**Agenda Item:** 9.2.1

**Source:** Ericsson

**Title:** **Proposed changes to the RRC protocol specification regarding RRC connection establishment and re-establishment procedures**

**Figure 14) Procedure for RRC connection establishment**

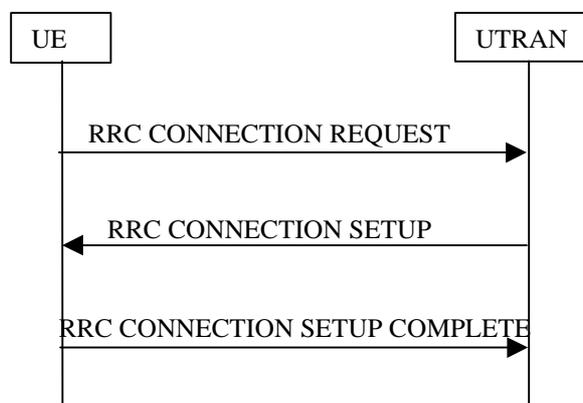
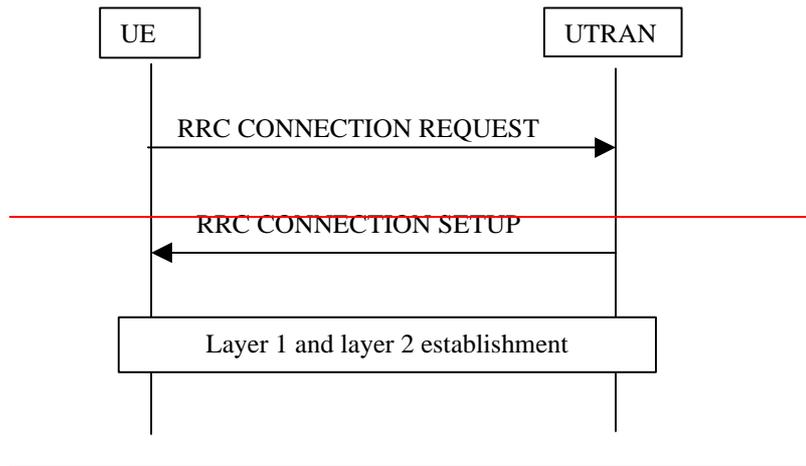
The procedure successfully ends when the ~~layer 2 signalling link is established on the DCCH~~ network receives an RRC CONNECTION SETUP COMPLETE message. The message, which is sent using acknowledged data transfer on the DCCH, confirms the assigned parameters and includes the UE capability.

*[Note: The necessity of an explicit RRC CONNECTION SETUP COMPLETE MESSAGE from the UE to the UTRAN on layer 3 is FFS. One assumption is, that there is an explicit layer 2 peer-to-peer signalling to establish the signalling link, making an explicit RRC CONNECTION SETUP COMPLETE message on layer 3 unnecessary.]*

**Figure 22) RRC Connection re-establishment**

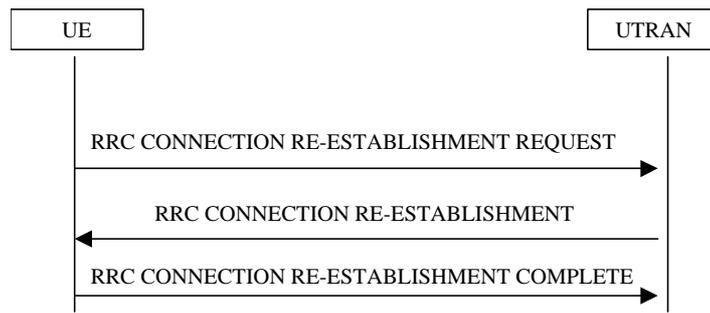
After the UE has completed its configuration, it transmits an RRC CONNECTION RE-ESTABLISHMENT COMPLETE message to the network on the DCCH.

*[Note: The necessity of an explicit RRC CONNECTION REESTABLISHMENT COMPLETE message to be sent from the UE to the UTRAN on layer 3 is FFS. One assumption is, that there is an explicit layer 2 peer to peer signalling to establish the signalling link, making an explicit RRC CONNECTION REESTABLISHMENT COMPLETE message on layer 3 unnecessary].*

**Figure 33) Procedure for transmission of UE capability information**

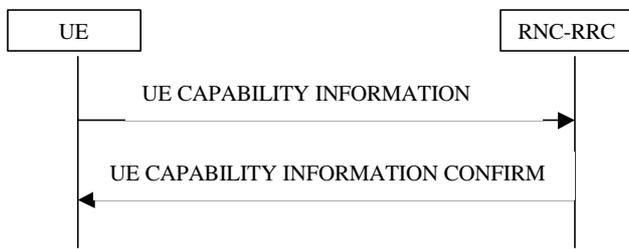
The UE transfers its capability information to the network by transmitting the UE CAPABILITY INFORMATION message on the DCCH. UTRAN acknowledges the successful update of UE capability by UE CAPABILITY INFORMATION CONFIRM message. This procedure can (optionally) be performed ~~after RRC Connection Setup procedure and also~~ during the lifetime of the RRC Connection if the UE capability information changes (e.g. due to change in UE power class). UE capability information can also explicitly be requested by UTRAN.
